Exhibit A

Recommended Amendments to the 2018 International Building Code City of Amarillo, Texas

The following sections, paragraphs, and sentences of the 2018 International Building Code are hereby amended as follows: Standard type is text from the IBC. Underlined type is text inserted. ~~Lined through type is deleted text from IBC.~~ A double asterisk (**) at the beginning of a section identifies an amendment carried over from the 2015 edition of the code and a triple asterisk (***) identifies a new or revised amendment with the 2018 code.

FIGURE 1511.3.1.1 HAIL EXPOSURE MAP

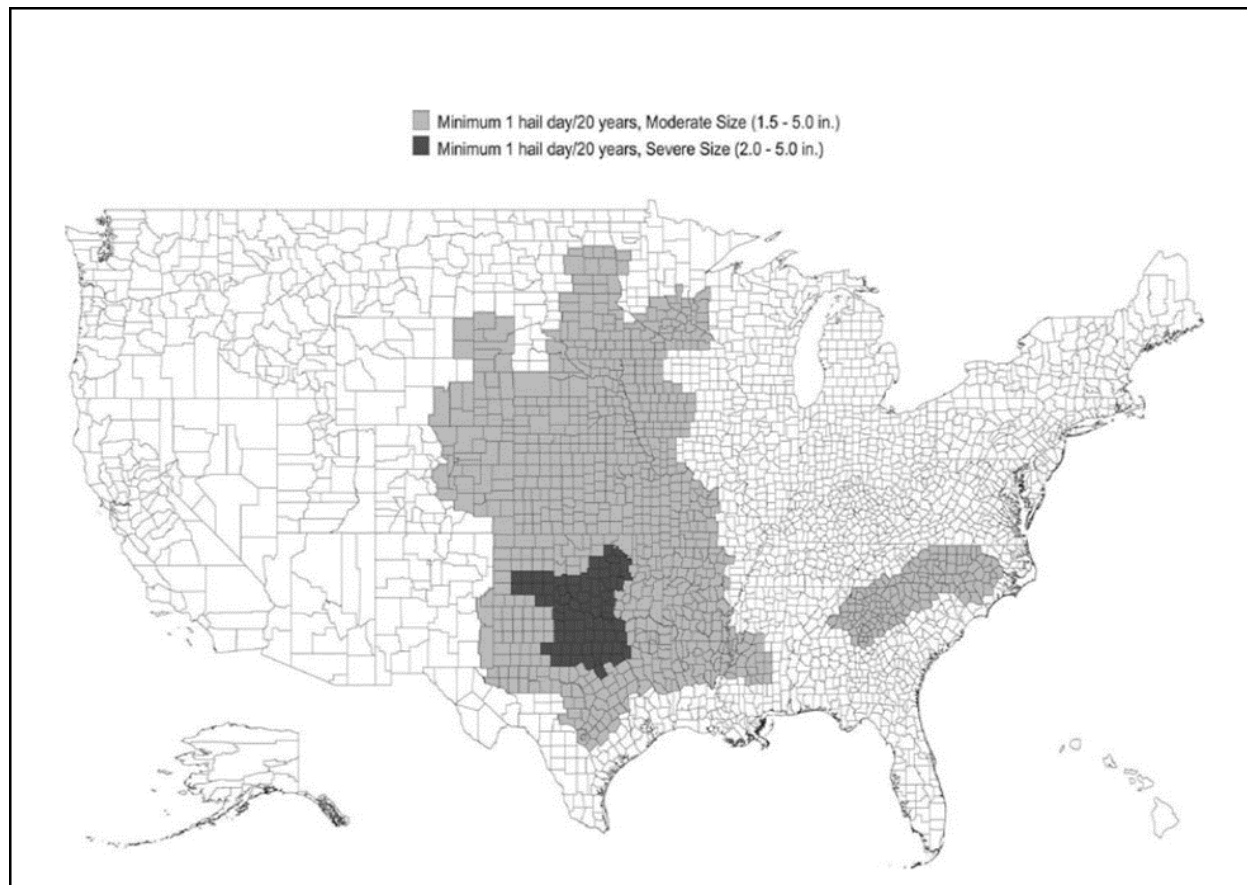
****Section 1511.3.1.1; insert Figure 1511.3.1.1; change to read as follows:**

1. Where the existing roof or roof covering is water-soaked or has deteriorated to the point that the existing roof or roof covering is not adequate as a base for additional roofing.
2. Where the existing roof covering is wood shake, slate, clay, cement or asbestos-cement tile.
3. Where the existing roof has two or more applications of any type of roof covering.
4. For asphalt shingles, when the building is located in an area subject to moderate or severe hail exposure according to Figure 1511.3.1.1.

(Reason: Due to the of weather in the Panhandle, wind and hail damage is more prone when asphalt shingles used for re-covering; contractors unable to verify if any of the decking may need to be replaced and unable to verify the flashing integrity)

*****Figure R602.6.1; delete the figure and insert the following figure:**

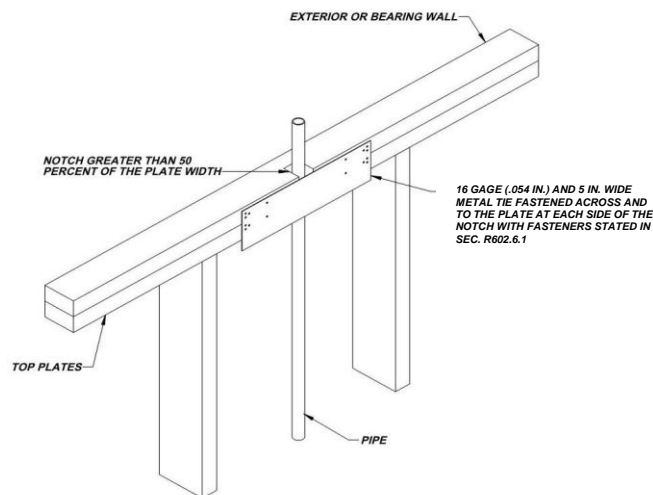
R602.6.1 Drilling and notching of top plate. When piping or ductwork is placed in or partly in an exterior wall or interior load-bearing wall, necessitating cutting, drilling or notching of the top plate by more than 50 percent of its width, a galvanized metal tie not less than 0.054 inch thick (1.37 mm) (16 Ga) and 4 ½ inches (38 mm) 5 inches (127 mm) wide shall be fastened across and to the plate at each side of the opening with not less than eight 10d (0.148 inch diameter) nails having a minimum length of 1½ inches (38 mm) or eight (#10) wood screws having a minimum length of not less than 1½ inch (38 mm) at each side or equivalent as approved by the Code Official. Fasteners will be offset to prevent splitting of the top plate material. The metal tie must extend a minimum of 6 inches past the opening. See figure R602.6.1. {Remainder unchanged}

(Reason: Amendment to provide additional assurance of maintaining the integrity of the framing by spreading the nailing/screw pattern.)

FIGURE R908.3.1.1 HAIL EXPOSURE MAP

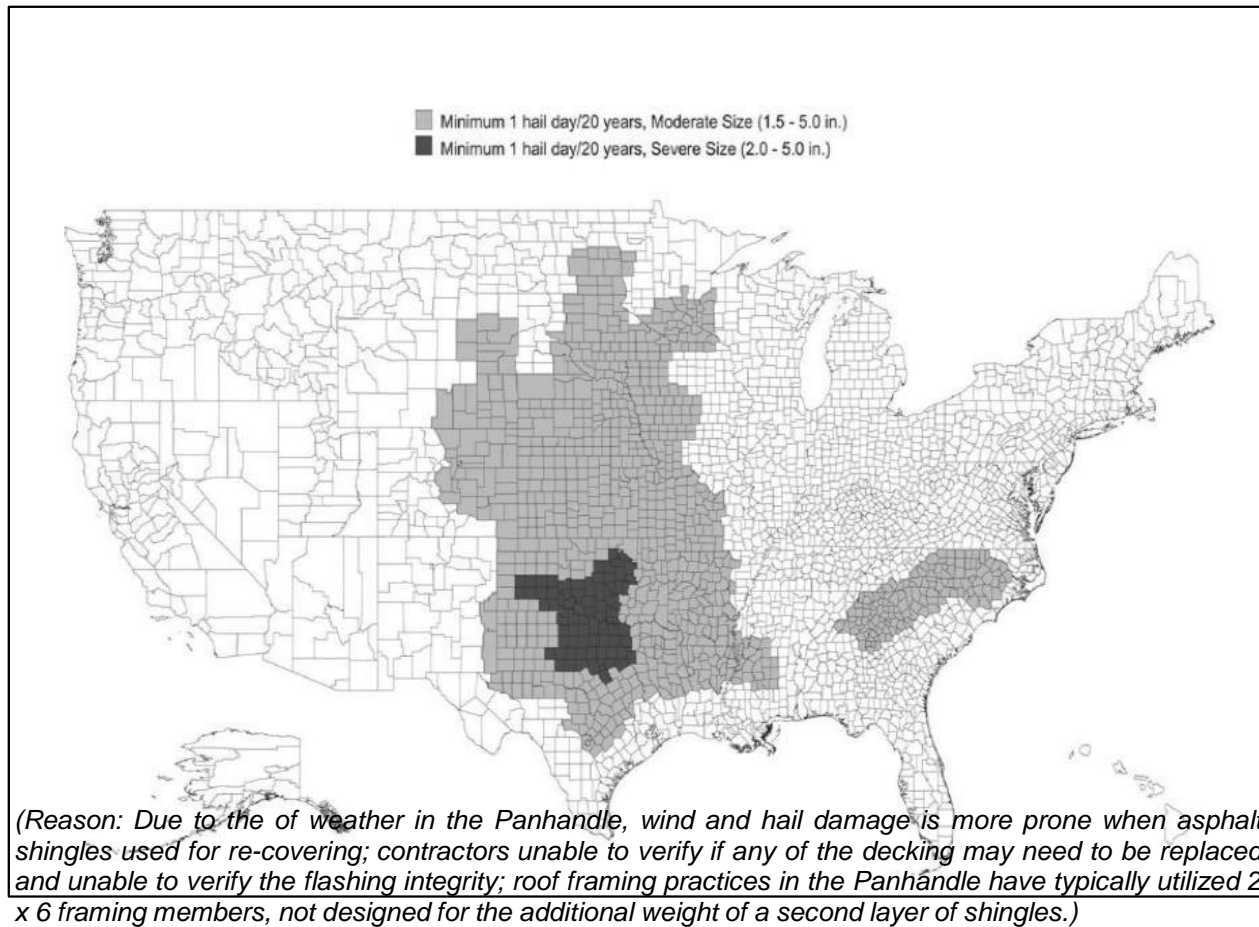
****Section R908.3.1.1; insert Figure R908.3.1.1; change to read as follows:**

1. Where the existing roof or roof covering is water-soaked or has deteriorated to the point that the existing roof or roof covering is not adequate as a base for additional roofing.
2. Where the existing roof covering is wood, slate, clay, cement or asbestos-cement tile.
3. Where the existing roof has two or more applications of any type of roof covering.
4. For asphalt shingles, when the building is located in an area subject to moderate or severe hail exposure according to Figure R908.3.1.1.

FIGURE 706.3 HAIL EXPOSURE MAP

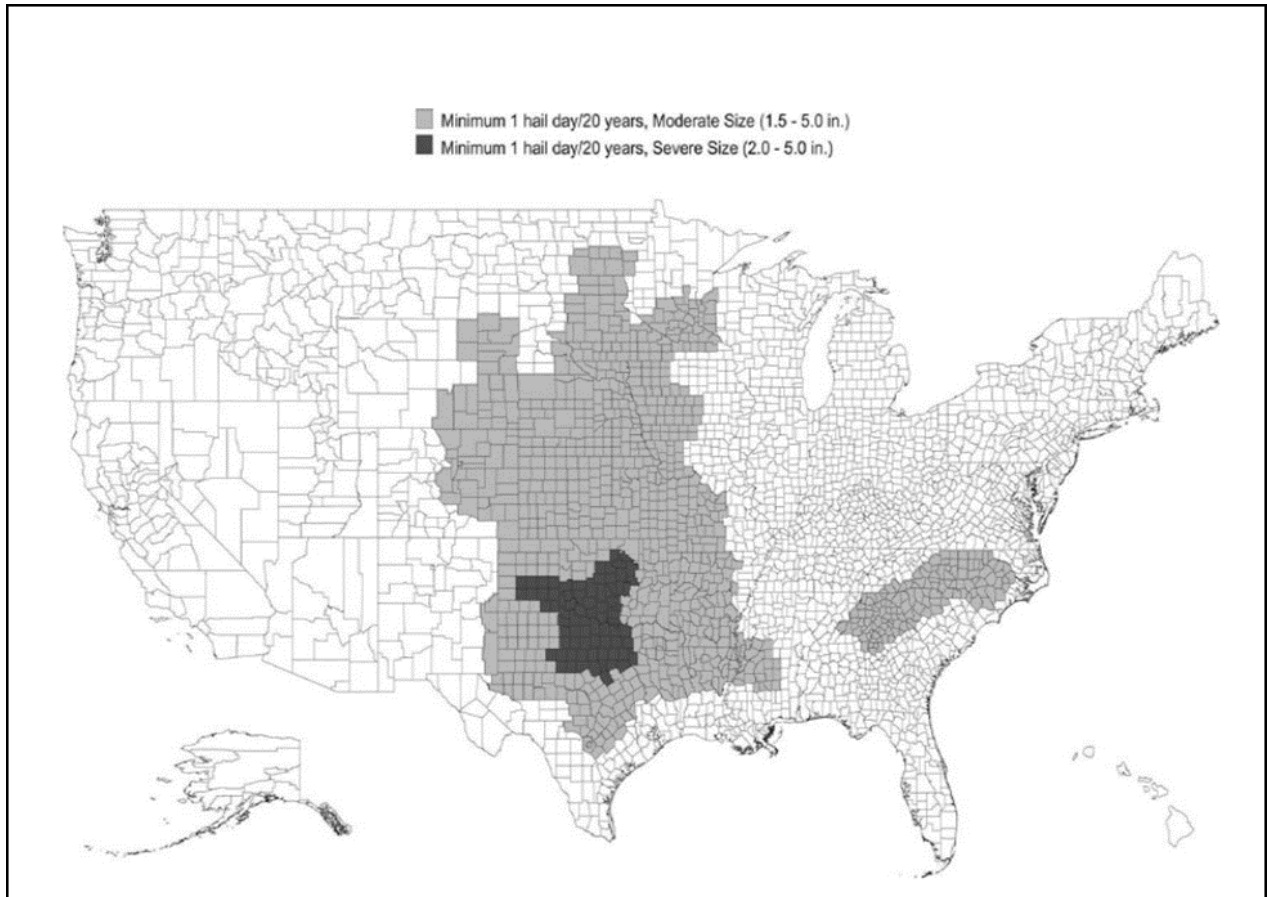
706.3.3 Roof re-covering. A roof re-cover shall not be permitted where any of the following conditions occur:

1. Where the existing roof or roof covering is water-soaked or has deteriorated to the point that the existing roof or roof covering is not adequate as a base for additional roofing.
2. Where the existing roof covering is wood shake, slate, clay, cement or asbestos-cement tile.
3. Where the existing roof has two or more applications of any type of roof covering.
4. For asphalt shingles, when the building is located in an area subject to moderate or severe hail exposure according to Figure 706.3.

ADD: Figure: 25 TAC §265.186 (e) (6)

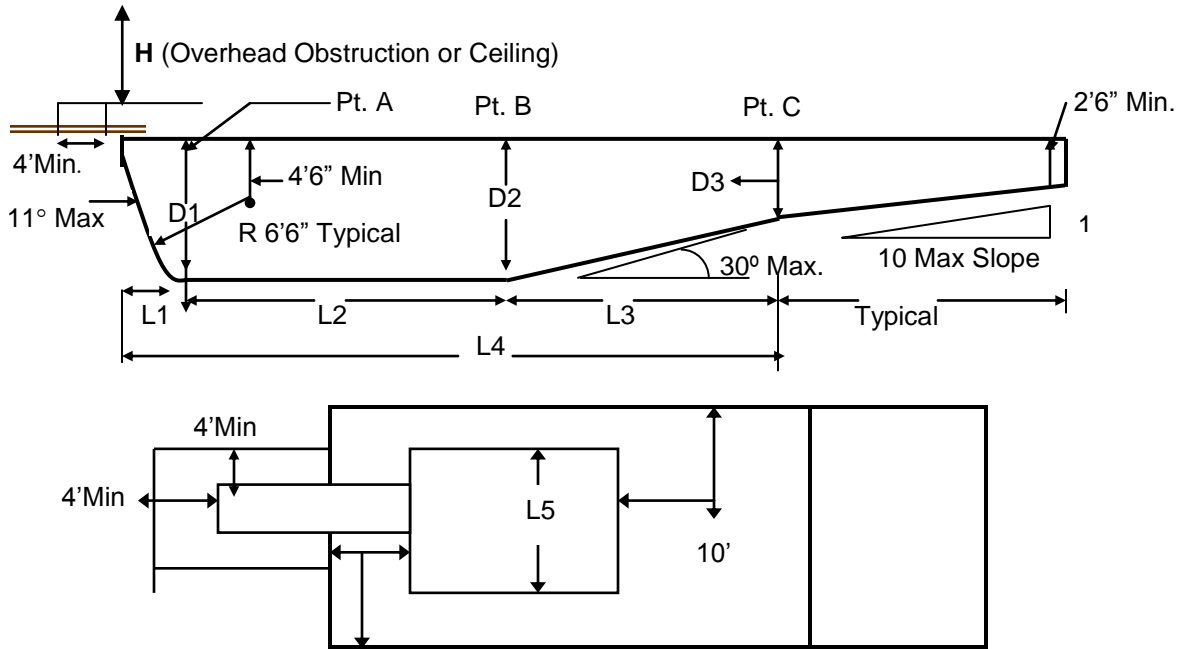
402.12 Water envelopes. The minimum diving water envelopes shall be in accordance with ~~Table 402.12 Texas Department of State Health services, Administrative Code Title 25, Chapter 265, Section 186 (e) and Figure: 25 TAC 256 265.186 (e) (6).~~ (Delete Table 402.12 and Figure 402.12)

(Reason: To avoid conflict with 25 TAC Chapter 265.)
